LINE	QUANTITY	UOP	CAT NO.	ITEM NUMBER	UNIT PRICE	AMOUNT
				ADDENDUM NO.2		
				ADDENDUM FOR THE LAND RECLAMATION PROJECT: "VALLEY POINT" PROJECT ISSUED TO PUBLISH THE ATTACHED INFORMATION, PER THE ATTACHED.		
				1. QUESTIONS AND ANSWERS 2. REVISED BID SHEET & SPECS 3. PRE-BID SIGN IN SHEET		
				END OF ADDENDUM NO.2		
0001	1	JB		962-73		
				RECLAMATION: RESTORATION OF LAND & OTHER PROPERTIES		
***** THIS IS THE END OF RFQ DEP15983 ***** TOTAL:

Addendum Number: 02

Addendum - Questions During Pre-Bid Meeting

Valley Point #2

**DETAIL XX
GROUT KEY**

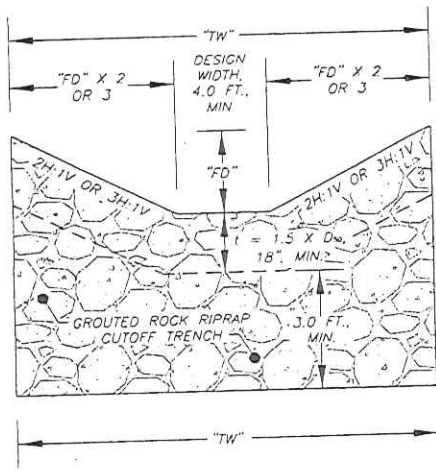
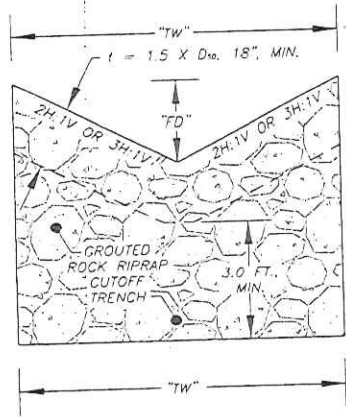
A Grout Key shall be installed at approximately STA 14+25 between the end of the riprap ditch that is depicted by Detail 2/24 and the beginning of the grouted riprap ditch depicted by Detail 3/24.

THE ENGINEERING CONSULTANT SHALL ENSURE THAT RIPRAP DITCH QUANTITIES END AND GROUDED RIPRAP QUANTITIES BEGIN AT THE UPSTREAM EDGE OF THE GROUT KEY.

1. EXTEND GROUT KEY LATERALLY THE FULL WIDTH OF THE CHANNEL AS SHOWN IN THE CROSS SECTION VIEWS.
2. INSTALL GROUT KEY AT THE JUNCTION OF ROCK RIPRAP CHANNEL WITH GROUDED ROCK RIPRAP CHANNEL AS SHOWN IN THE PROFILE VIEW.
3. AFTER EXCAVATING THE GROUT KEY TO THE DIMENSIONS SHOWN, PLACE GROUT IN THE EXCAVATION TO THE CHANNEL SUB GRADE PRIOR TO PLACING THE RIPRAP.
4. "TW" = TOP WIDTH
"Fb" = FREEBOARD DEPTH
"F.D." = FLOW DEPTH
"t" = THICKNESS
